South Texas Project Electric Generating Station
Units 1 and 2
Docket Nos. STN 50-498, STN 50-499
Revised Spacing of the
High Density Spent Fuel Racks

ANNOTATED REVISIONS TO THE HIGH
DENSITY SPENT FUEL RACKS
SAFETY ANALYSIS REPORT
(REFERENCE 1, ATTACHMENT 3)

ANNOTATED REVISION TO SECTION 9.1 OF THE
FINAL SAFETY ANALYSIS REPORT

Figure 3-1

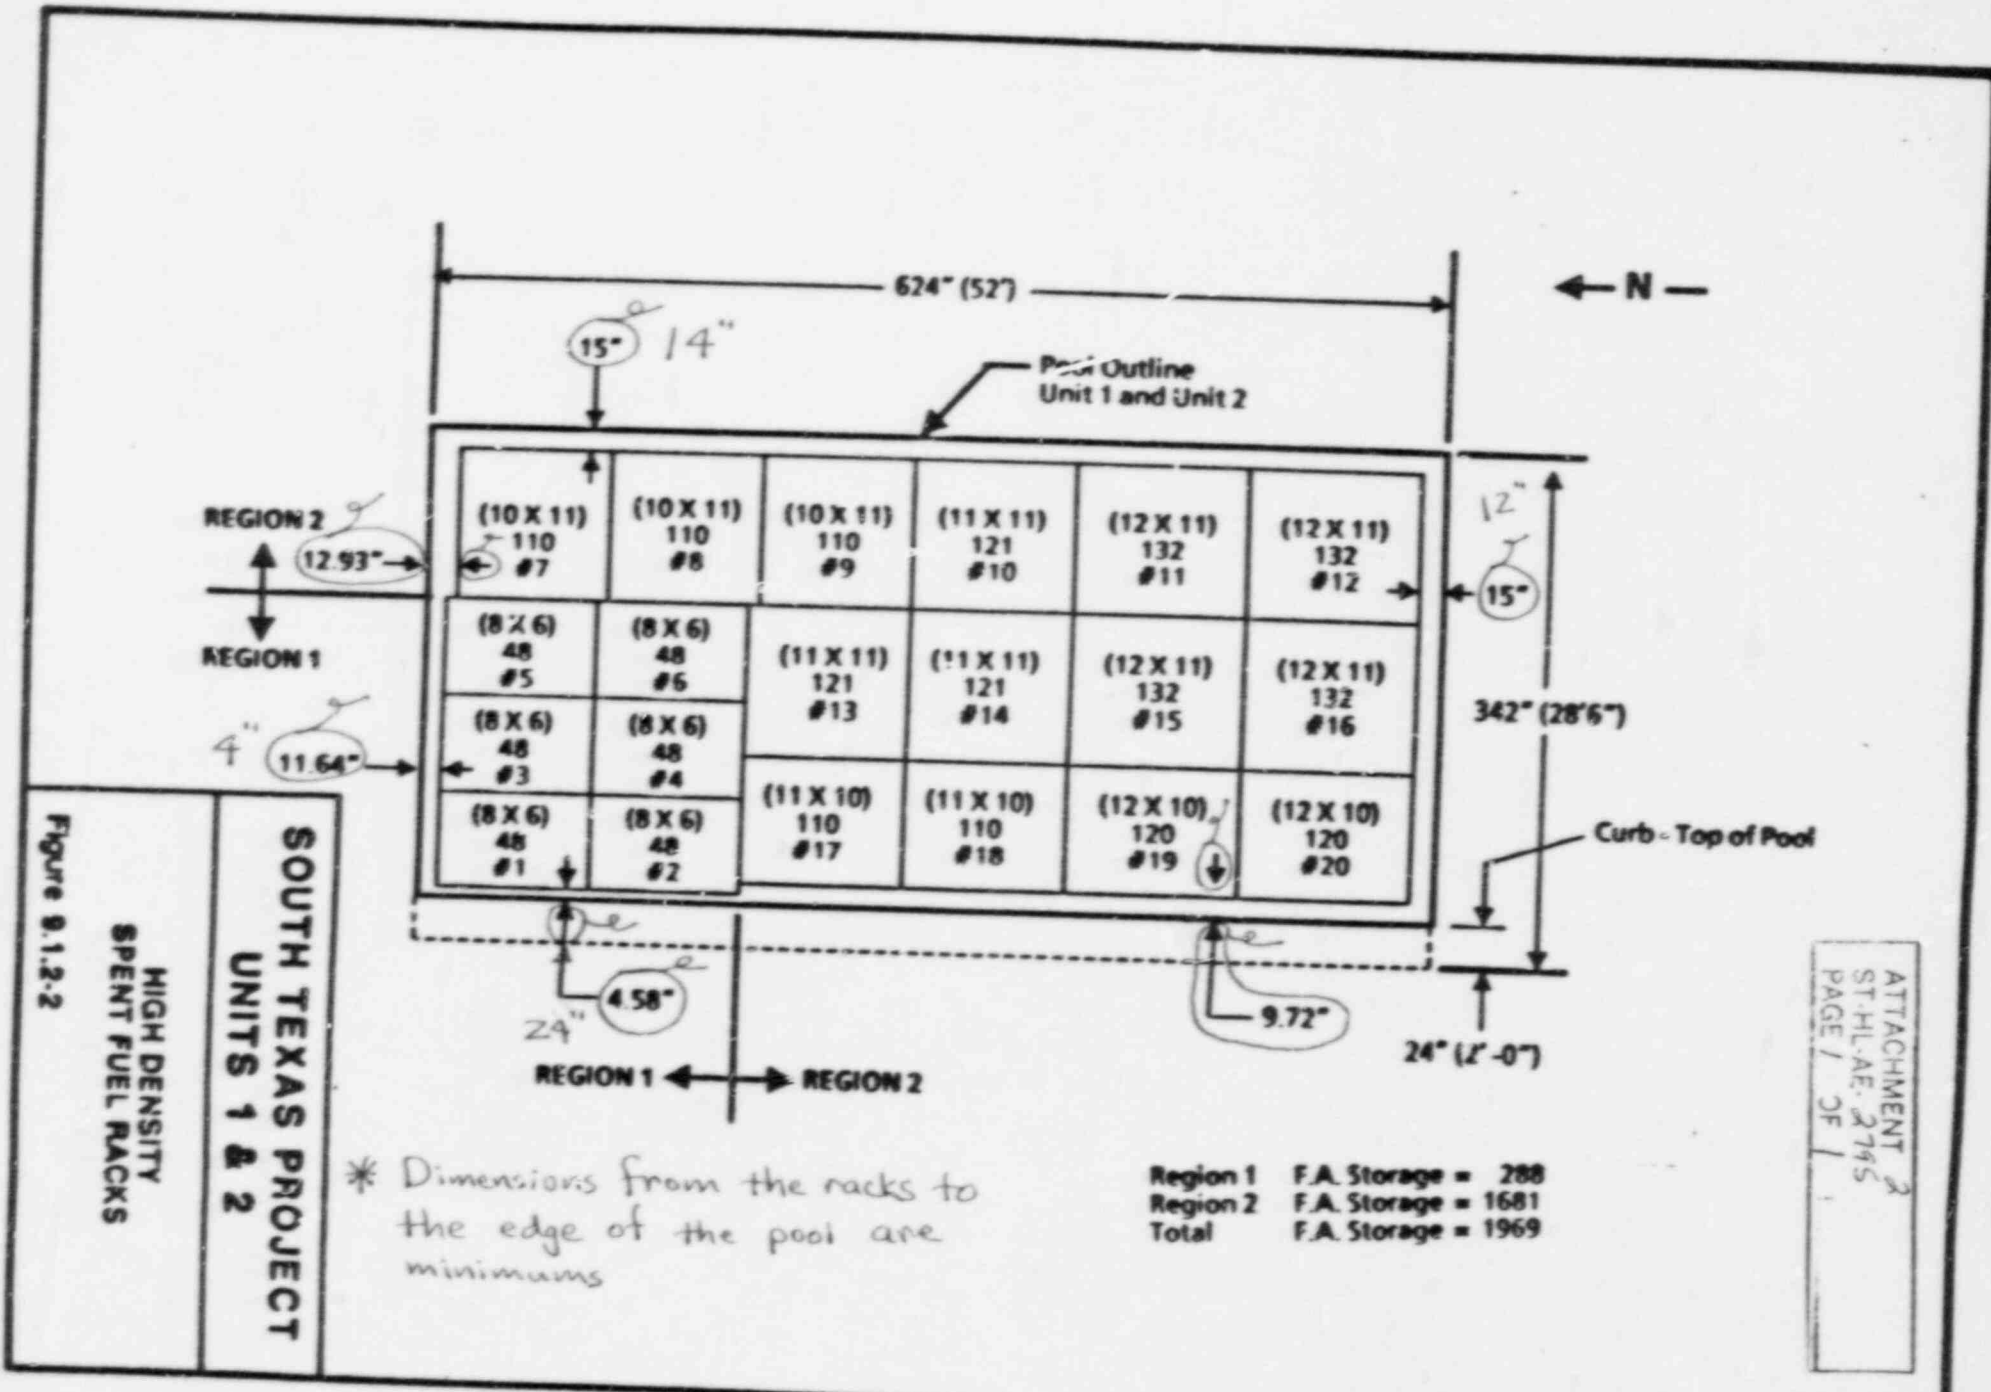
- J. The effect of sloshing is neglected.
- K. The racks will be installed with *a one-inch rack-to-rack* ~~no rack-to-rack~~ gap. Rack-to-rack hydrodynamic coupling is not modeled because very strong hydrodynamic coupling forces cause the racks to move together.

All racks are installed with ^{a one-inch} ~~no~~ rack-to-rack gap. The racks move together because of the very strong hydrodynamic coupling forces.

* Dimensions from the racks to the edge of the pool are minimums
